P 534530

**ON-SITE SEWAGE DISPOSAL SYSTEM
HOWARD COUNTY HEALTH DEPARTMENT
BUREAU OF ENVIRONMENTAL HEALTH**

SUBDIVISION: Riverwood LOT NUMBER: 4

ADDRESS: 11063 Hunters View Road PROPERTY OWNER: Winchester Homes

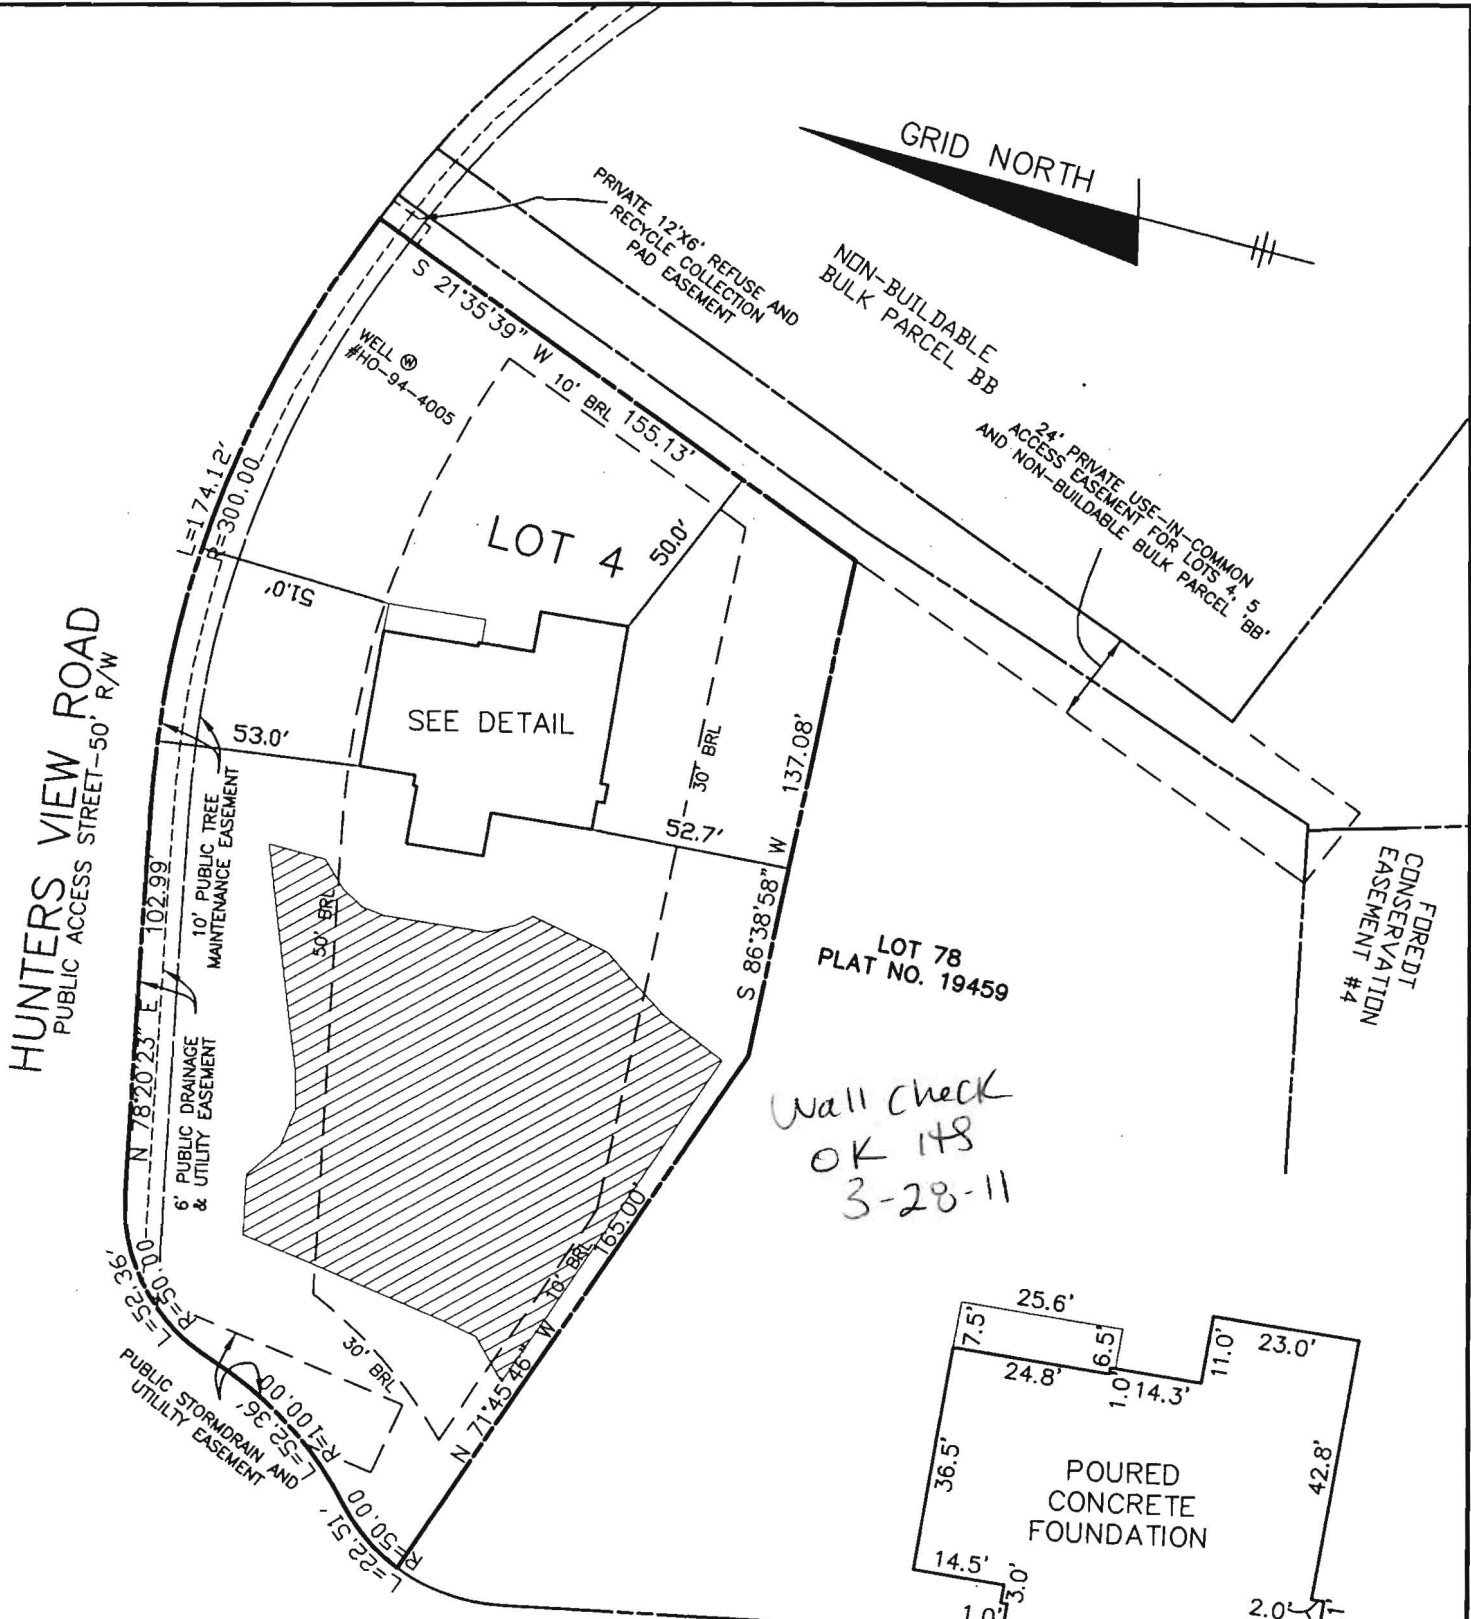
5/20/2011 Still covering top of easement. Agreed that it was O.K. to set the tank near where shown but farther from the well box on lot 78. Remove fill and schedule trench layout. (BB)

INSTALLATION: 5/26/2011 O.K. to set tank mostly in easement. Place box where shown on B.P. plan. Install 2 trenches on contour towards Hunters View Road (Upper 70' and lower 68' trench). Install one 58' trench on contour towards lot 78. See B.P. plan. Use laser for 58' trench. (BB)

6/2/2011 Tank set. House connection made. Starting on trenches.
6/3/2011 System finished. O.K. to back fill. (BB)
